Intel[®] StrongARM^{*} SA-1110 Microprocessor

Specification Update

December 2000

Order Number: 278259-020

27. **DMA Control/Status Register (DCSRn): Section 11.6.1.2**

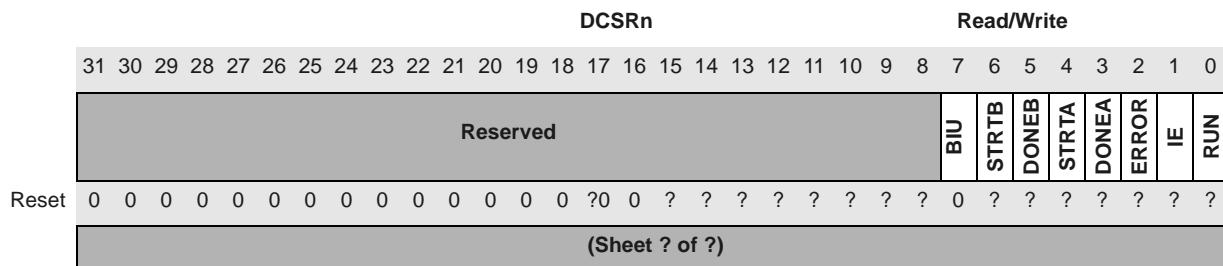
Changed DMA control/status register bit-0 from RUNE to RUN and changed the reset value of BIU (Bit 7) from "?" to "0".

Figure 11-3. Palette Buffer Format

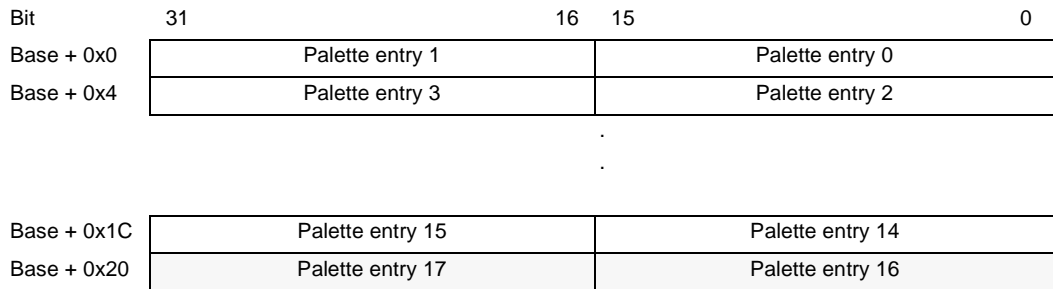
Also in this section, changed 254 to 255 in Figure 11-3. The figure now appears as follows:
